**APPENDIX 4B**

**DETAILED DRAWINGS FOR THE 200 AREA EFFLUENT TREATMENT FACILITY  
CONTAINER STORAGE AREA AND TANK SYSTEMS**

1. ECN 647892

ECN 647247 - 8/21/98  
Page 9 of 12  
Block 13a Cont'd  
H-2-817976 Sh 1 Rev 1  
Zone A4-D6  
IS NOW:

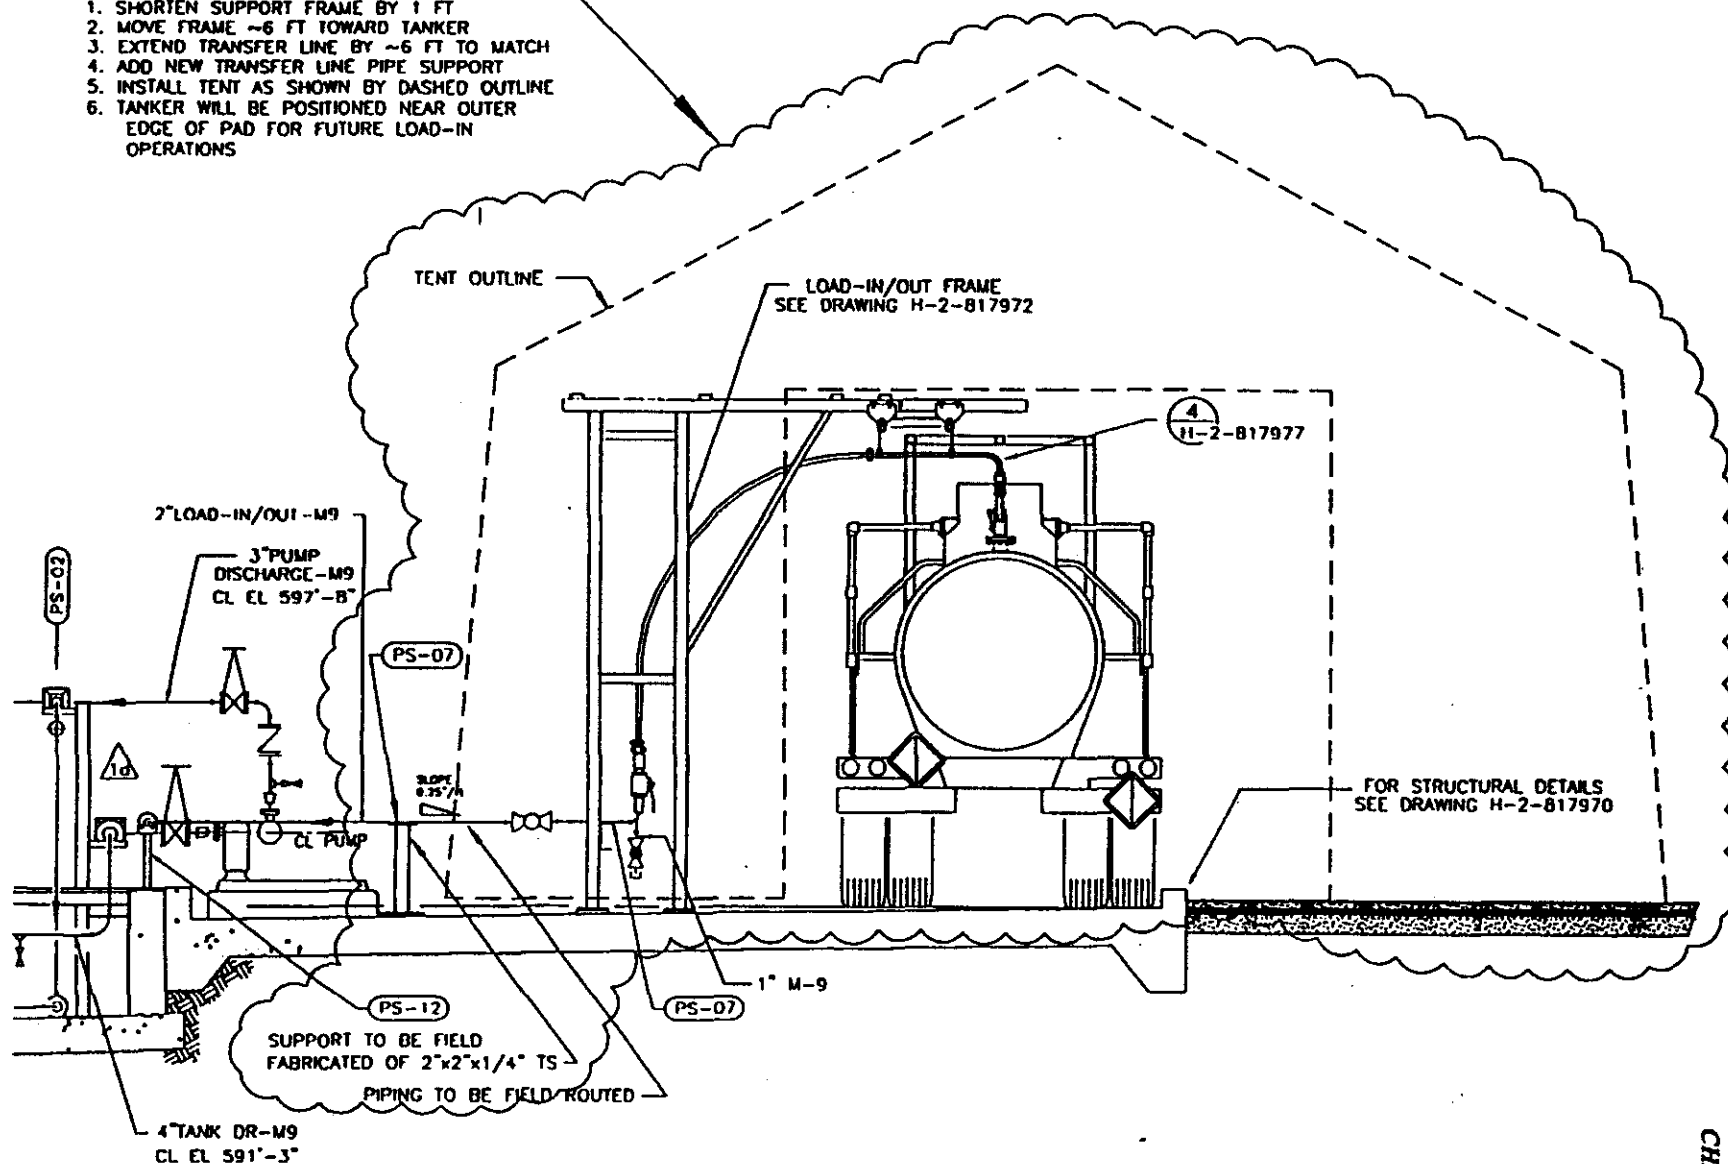
1. SHORTEN SUPPORT FRAME BY 1 FT
2. MOVE FRAME ~6 FT TOWARD TANKER
3. EXTEND TRANSFER LINE BY ~6 FT TO MATCH
4. ADD NEW TRANSFER LINE PIPE SUPPORT
5. INSTALL TENT AS SHOWN BY DASHED OUTLINE
6. TANKER WILL BE POSITIONED NEAR OUTER EDGE OF PAD FOR FUTURE LOAD-IN OPERATIONS

H-2-817970, Sh 1 Rev 1

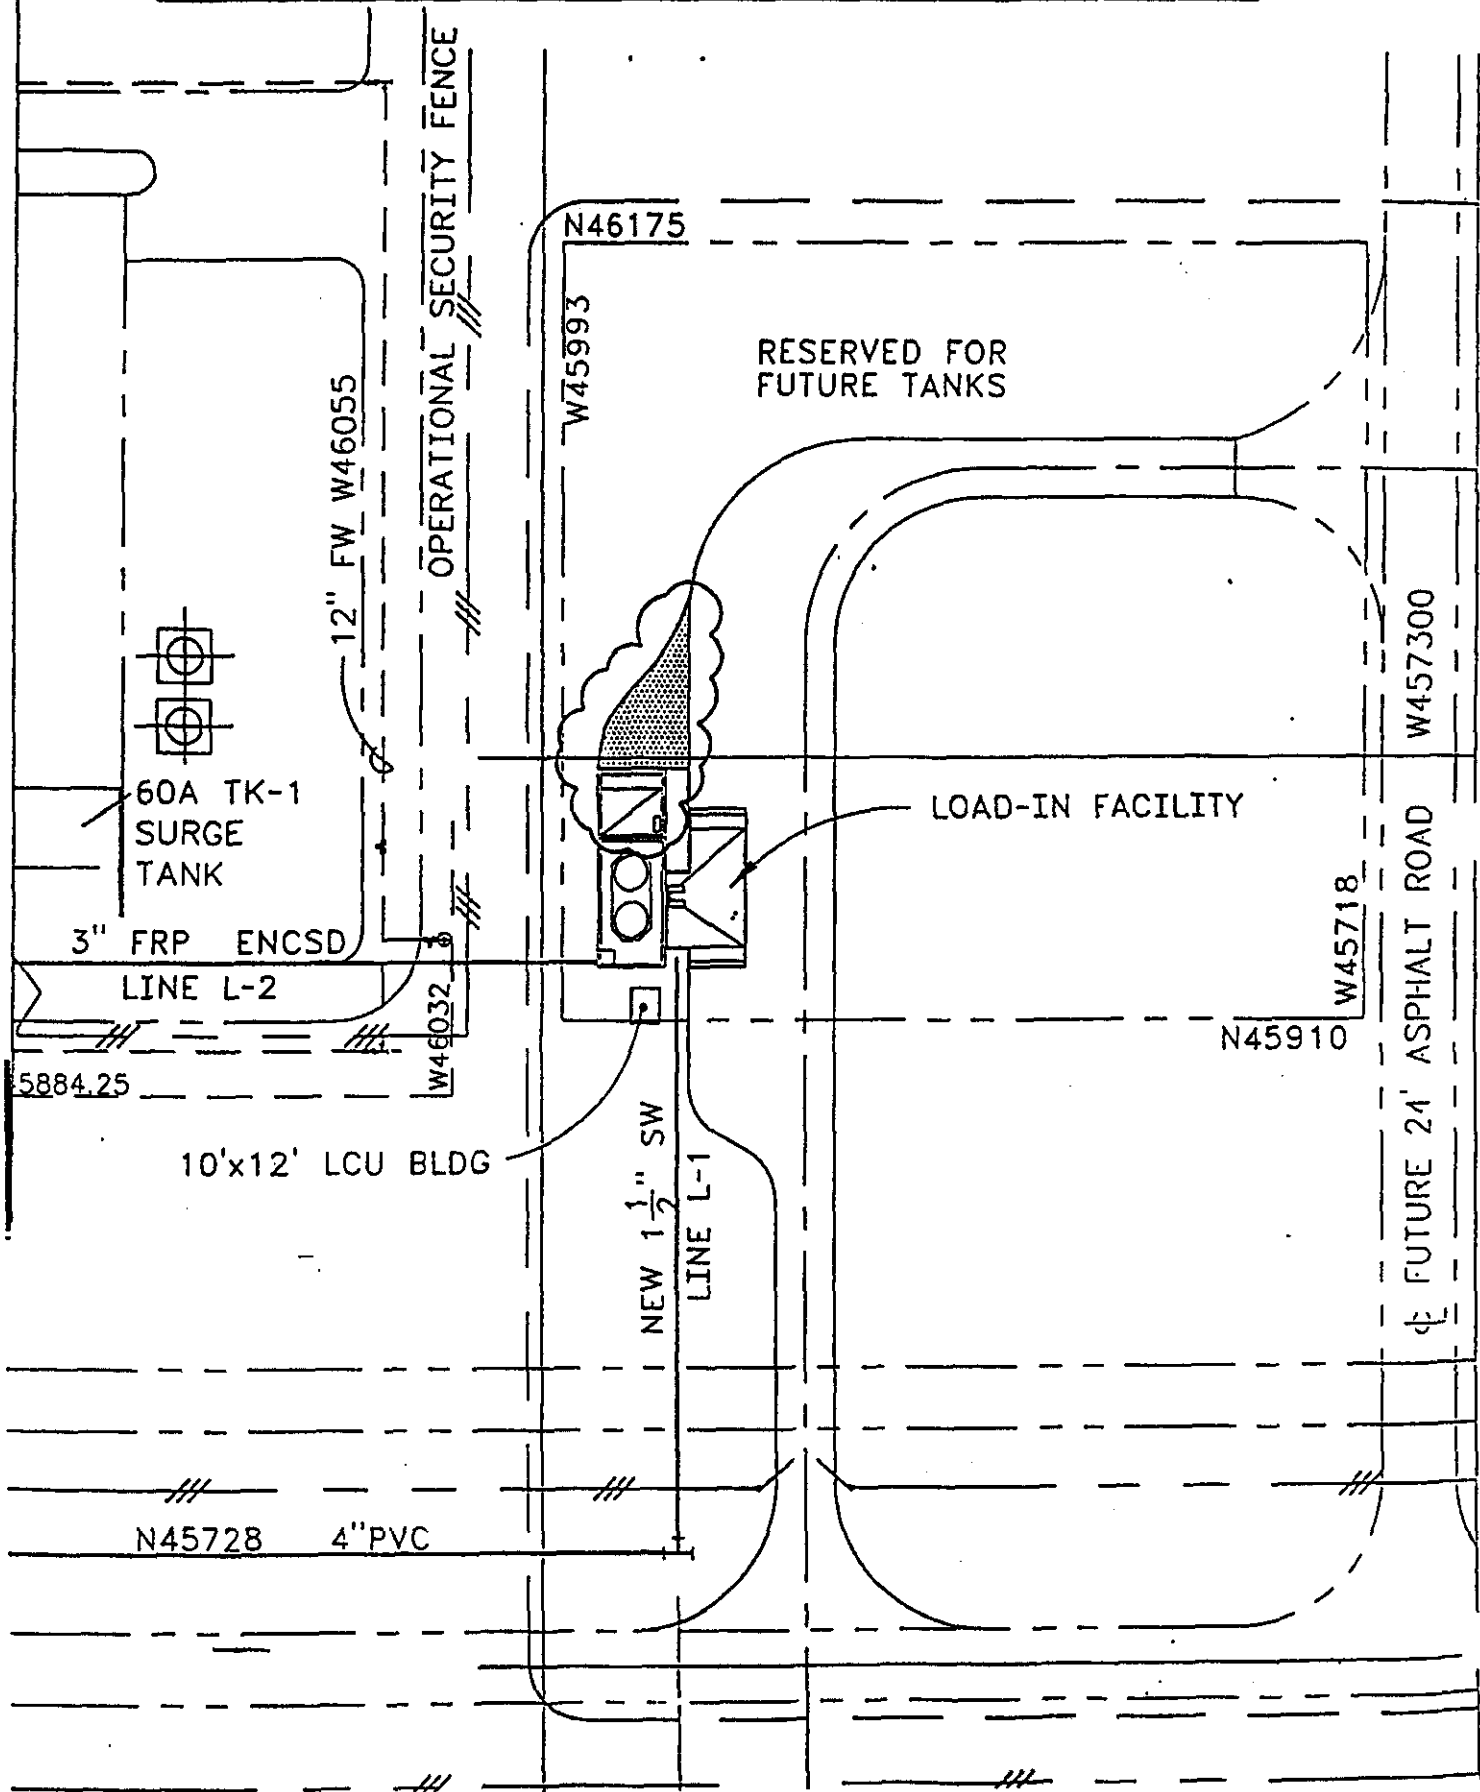
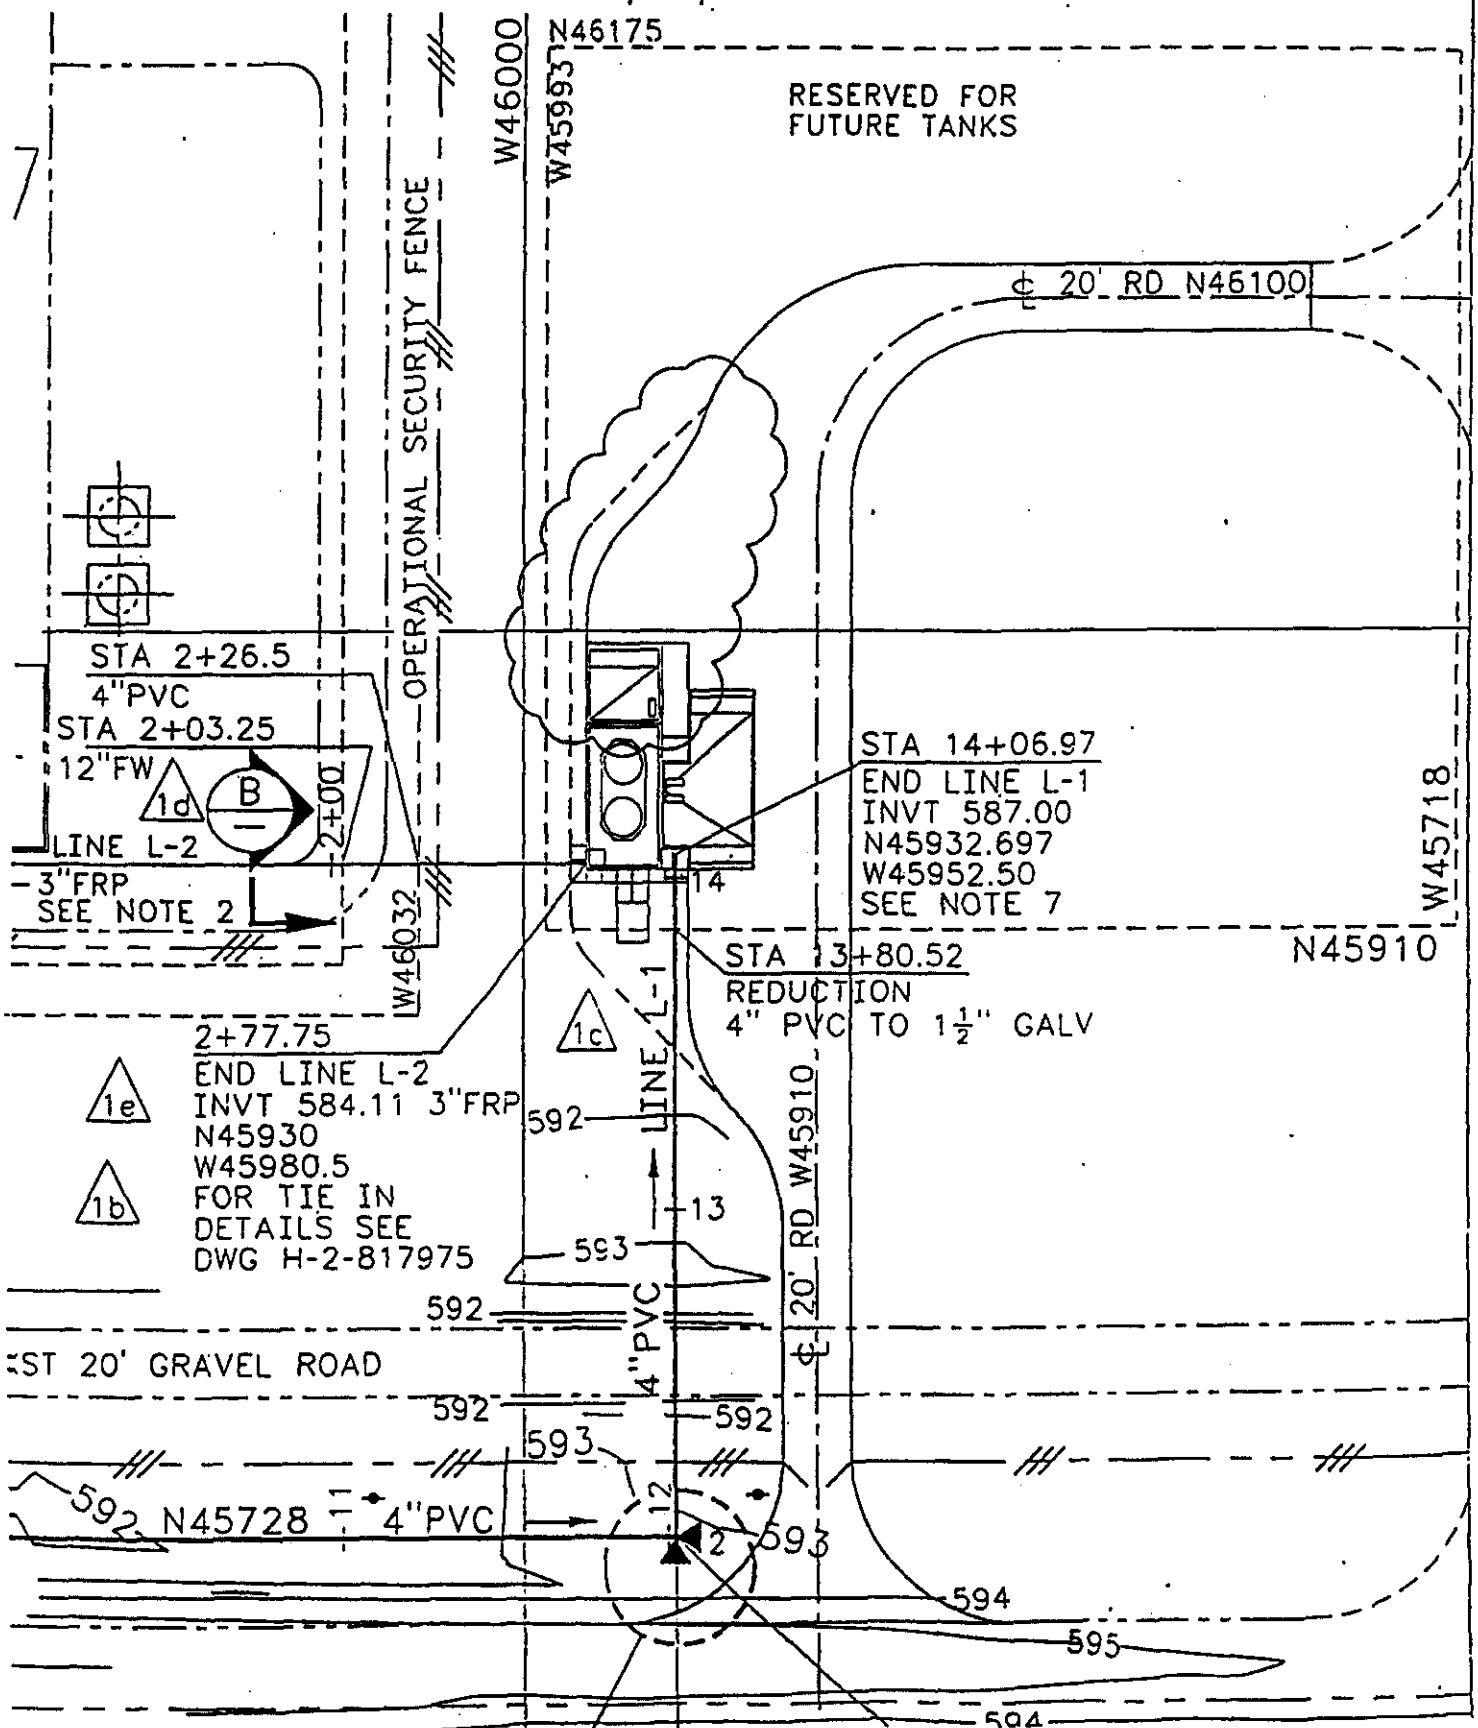
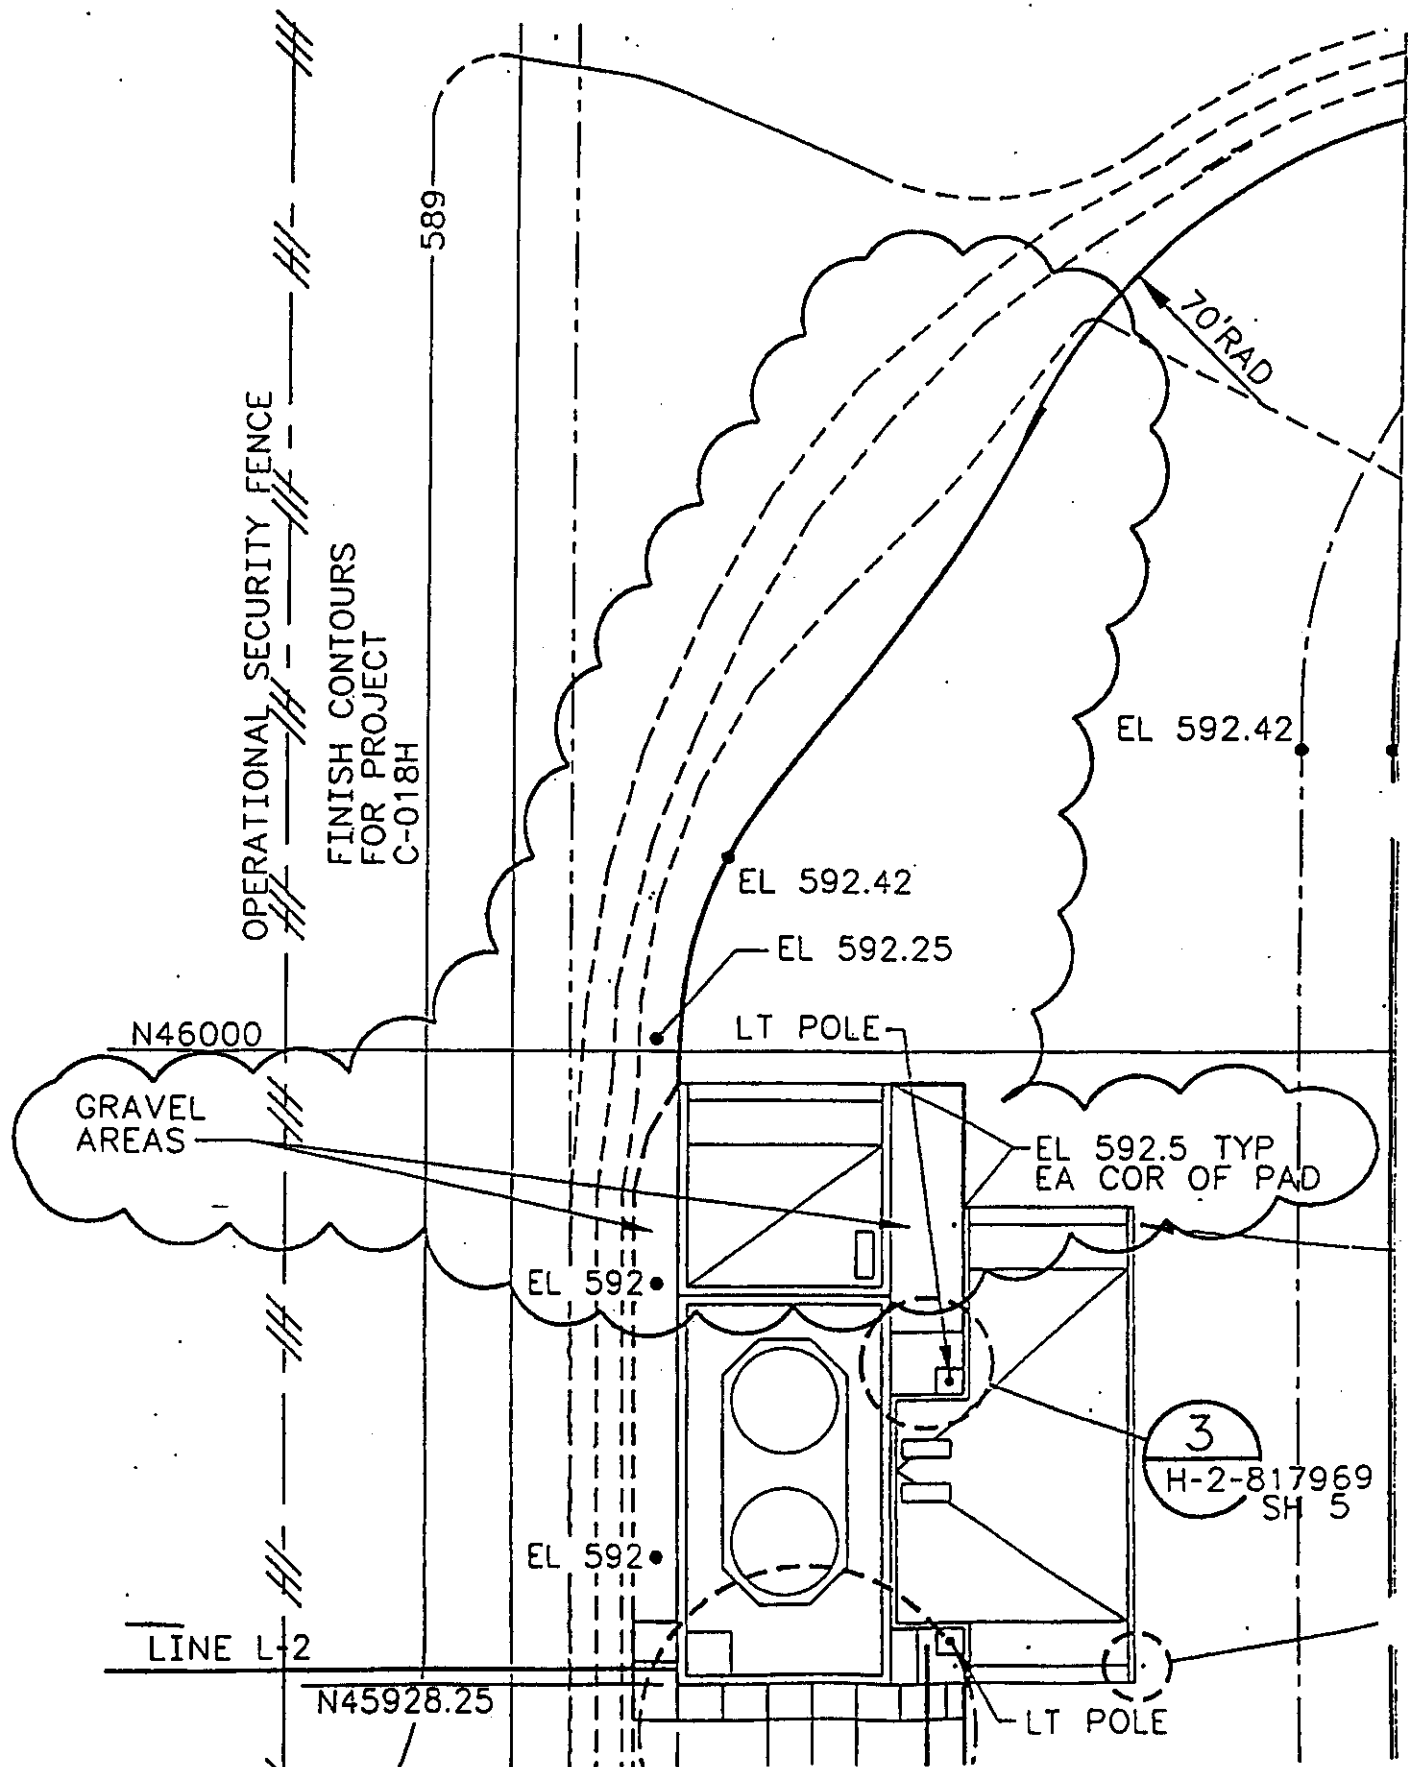
Zones C/F-5/8: Add asphalt and concrete pad areas, filter skid, pump base, dimensional details and Section G reference.

Zones A/D-4/8: Add Sections F and G and Detail 6. Add note to Section E identifying elevations of respective pump pads.

CHANGES/ADDITIONS ARE SHOWN IN CLOUDED AREA, MODIFY DRAWING AS SHOWN IN CLOUDED AREA..
